**Demolition of Former Delta Maple Syrup
Factory ADDENDUM #2**

A2-PW2025-9

This addendum is being released to clarify questions received on RFP 2025-9 for the demolition of the former Delta Maple Syrup Factory.

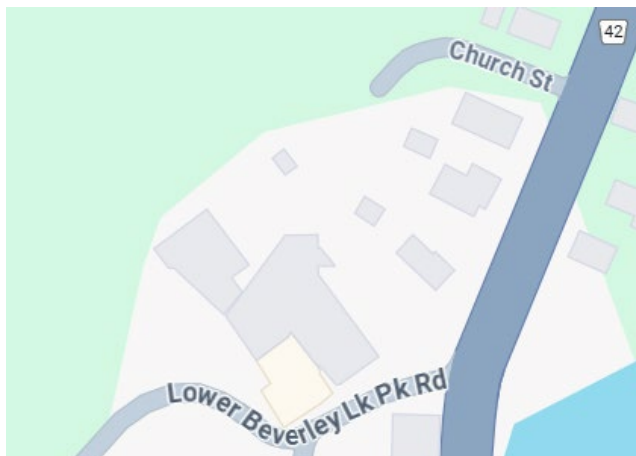
13. *I noticed all the no trespassing signs etc. What is that relationship like and where is the property line ? is there enough Public property that we can move a machine up that side of the property from front to back?*

A: See question 9 and 10 above and below for property lines in yellow.
